ALERT SERVICE BULLETIN

UH-1H-12-08

**MODEL AFFECTED:** UH-1H

**SUBJECT:** P/N 205-001-720-001 CABLE ASSEMBLY, ONE TIME INSPECTION FOR DEFECTIVE BODY, P/N 205-001-742-001

**Figure 1 (sheet 1 of 2)**

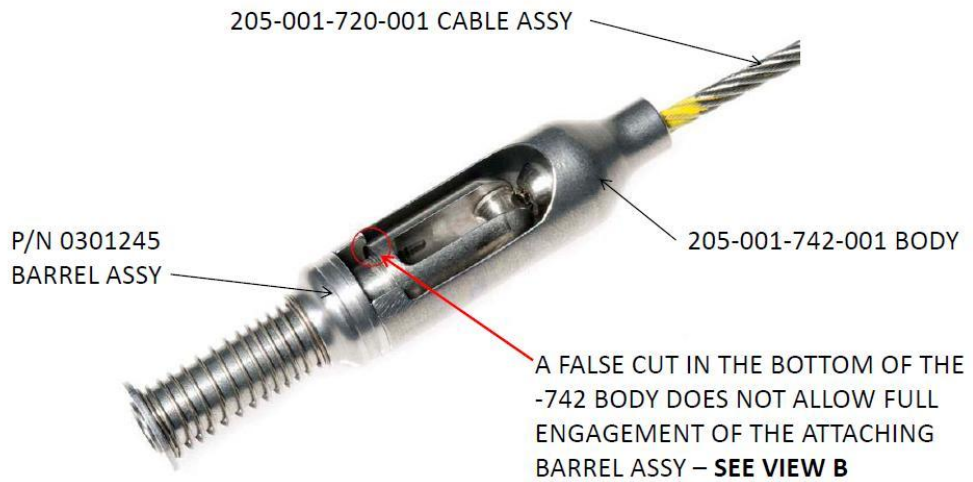
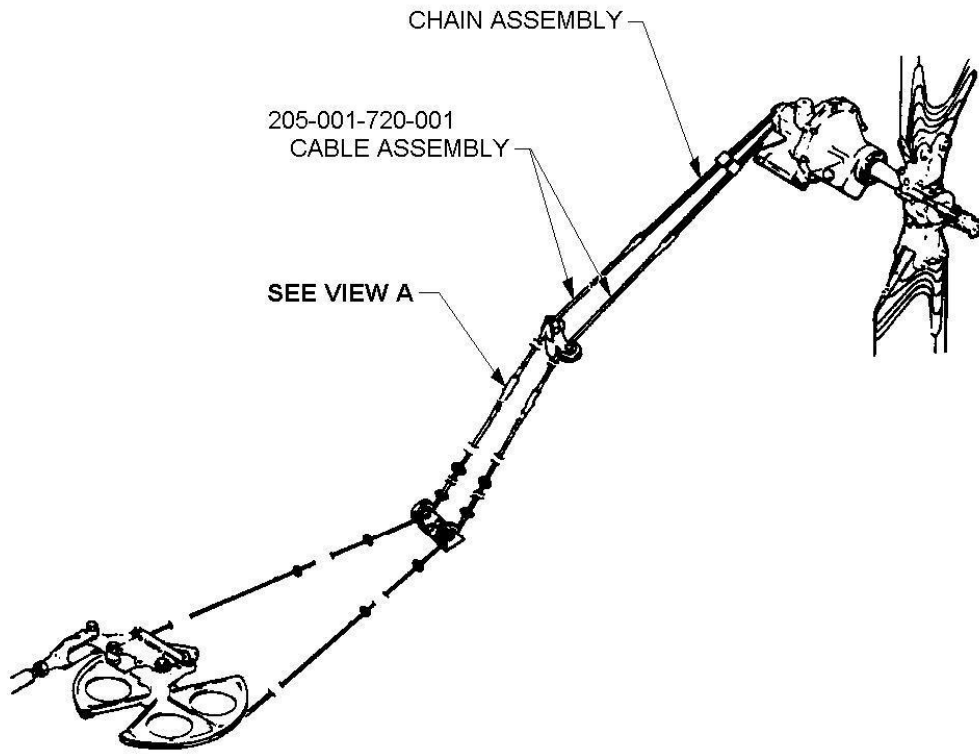
1. Prepare helicopter for maintenance.
2. Open the vertical fin tail rotor driveshaft cover.
3. Gain access to the lower ends of the P/N 205-001-720-001 Cable Assemblies at the connection to the P/N 0301245 Barrel Assembly. See Figure 1, sheet 1.

**Figure 1 (sheet 2 of 2)**

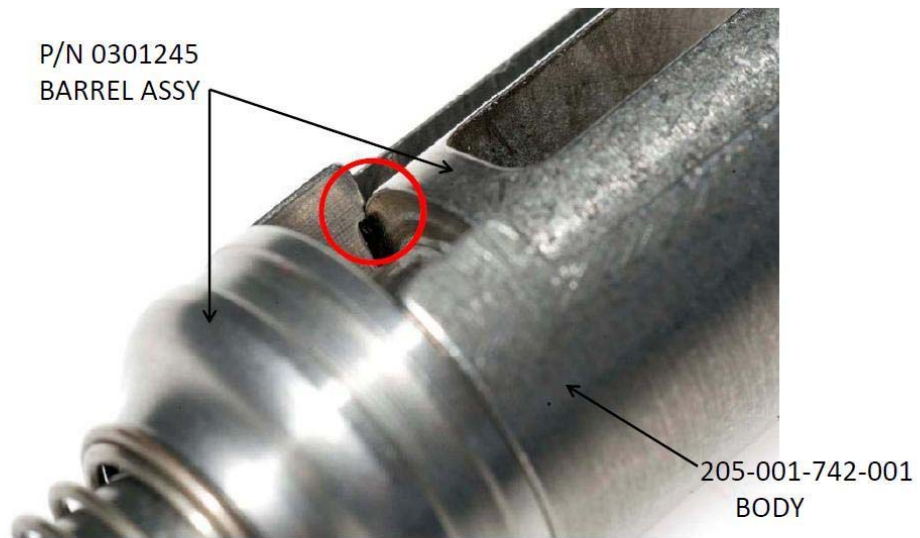
4. Refer to Figure 1, sheet 2. Inspect for the condition shown in View B that prevents complete seating of the P/N 0301245 Barrel Assembly in the bottom of the P/N 205-001-742-001 Body. As necessary, remove lockwire for a clear view.

5. The condition shown in Figure 1, sheet 2, View B, is not acceptable and is cause to replace the affected P/N 205-001-720-001 Cable Assembly.
6. For cable assemblies that fully engage the P/N 0301245 Barrel Assembly and do not exhibit the condition of View B, no further action is required. If lockwire was removed to facilitate inspection, secure barrel assembly and cable connection with new lockwire and make an entry in the helicopter records showing compliance with this ASB.

DETAIL OF INTERFERENCE CREATED BY FALSE CUT IN BODY

7. For defective cable assemblies, go to Part II.
